WHITIANGA ACCESSIBILITY AUDIT REPORT

Thames-Coromandel District Council (TCDC) has requested an accessibility audit for the Central Business District (CBD) area of Whitianga, with particular emphasis for disabled and elderly residents. The audit covers:

Figure 1: Cobblestones on Albert Street

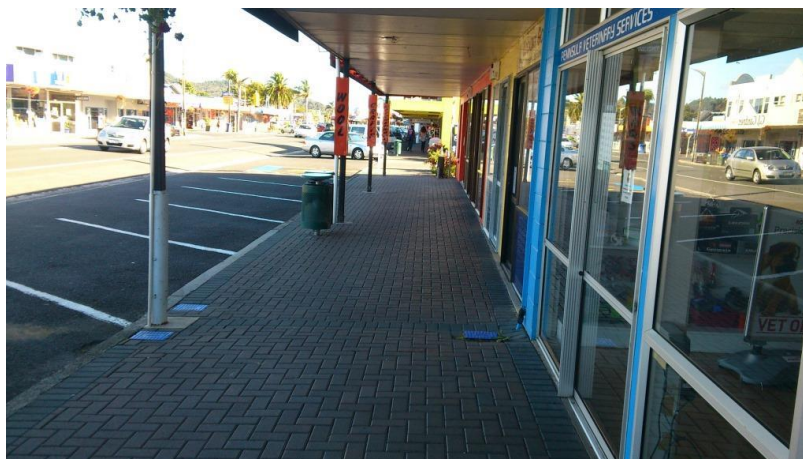
TCDC has used cobblestones to beautify the main shopping precinct. It was noted that during the time of the audit, these are currently in good condition. The cobblestones are just starting to show wear and tear.

Recommendation 75 Regularly monitor and replace cobblestones as required during the maintenance programme with asphaltic concrete or concrete to minimise potential tripping hazards when the cobblestones become loose or uneven due to underground service work or settlement of the basecourse.

Figure 8: Mobility Space at 70 Albert Street

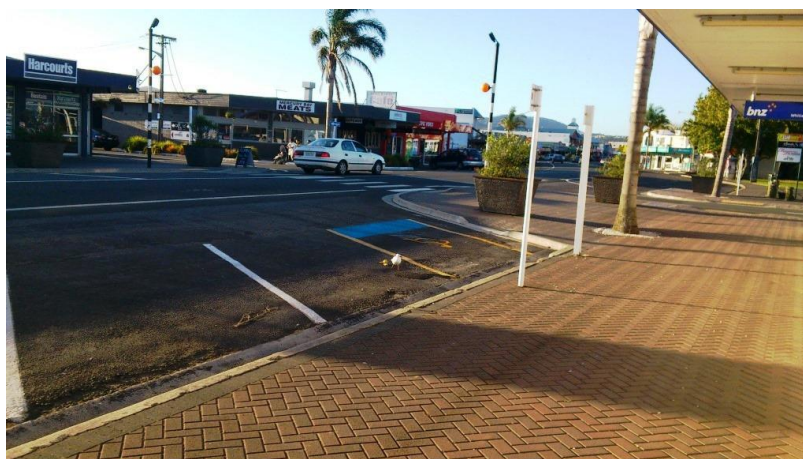
Overall, the condition of the Mobility Spaces provided in Whitianga is good with only the Mobility Space at 70 Albert Street needing to be re-surfaced.

Recommendation 13 Re-surface the Mobility Space at 70 Albert Street.

Figure 16: Kerb ramp on the east side crossing Eyre Street at Buffalo Beach Road

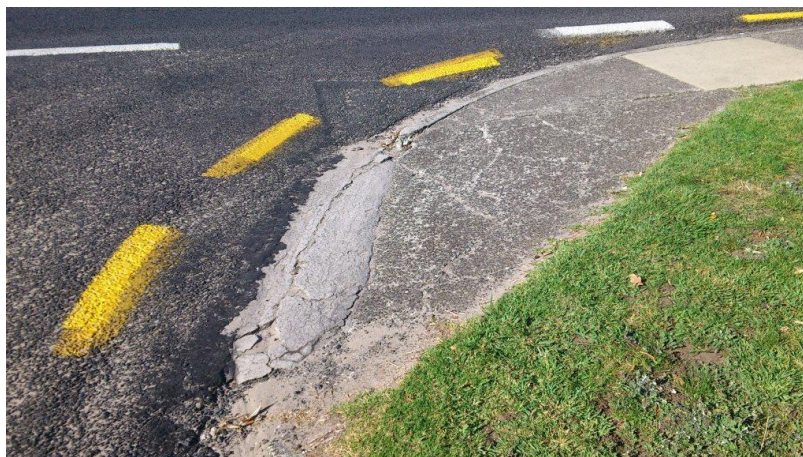
The SE kerb ramp crossing Eyre Street is uneven and broken (creating a tripping hazard), while the NW kerb ramp crossing Eyre Street utilises the driveway at 2a Eyre Street (Waterfront Apartments Whitianga). This extremely dangerous practise as a mobility scooter or wheelchair user is lower to the ground and is harder to see for vehicles reversing.

There are no kerb ramps for crossing Buffalo Beach Road at Eyre Street.

Recommendation 24 Replace the kerb ramp on the SE side of Buffalo Beach Road/Eyre Street intersection (crossing Eyre Street) to minimise a tripping hazard. Install a kerb ramp on the NW side crossing Eyre Street.

Figure 28: Steep kerb face on Monk Street

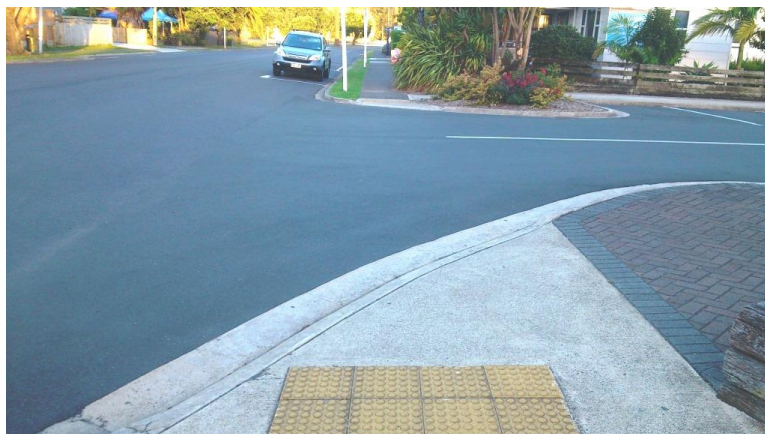
Monk Street provides a pedestrian link from the centre of town to the Wharf. New kerb ramps have been installed at the carpark opposite Mill Road that, although are flush, the face of the kerb is very steep and acts like a lip kerb.

Recommendation 38 Replace the kerb ramps at the entrance to the carpark on Monk Street with flush kerbs. Install kerb ramps as shown in figure 9 on the NW and NE corners of Monk Street and Mill Road, and separate the vehicle entrance to the Gull Service Station from the kerb ramp.

Figure 46: Service cover at 23 Albert Street

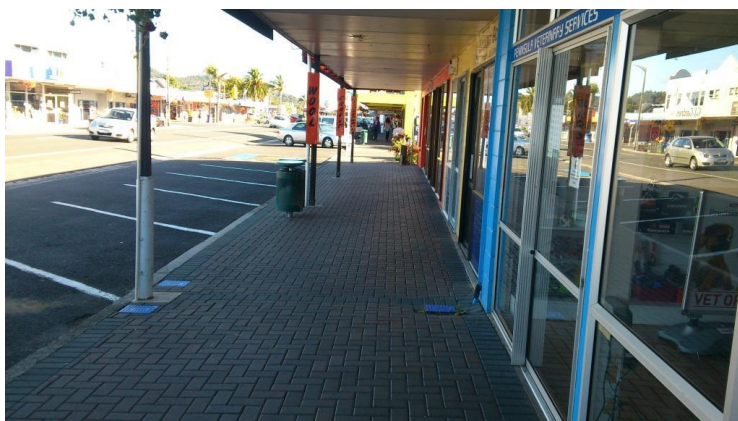
- Service cover at 23 Albert Street;
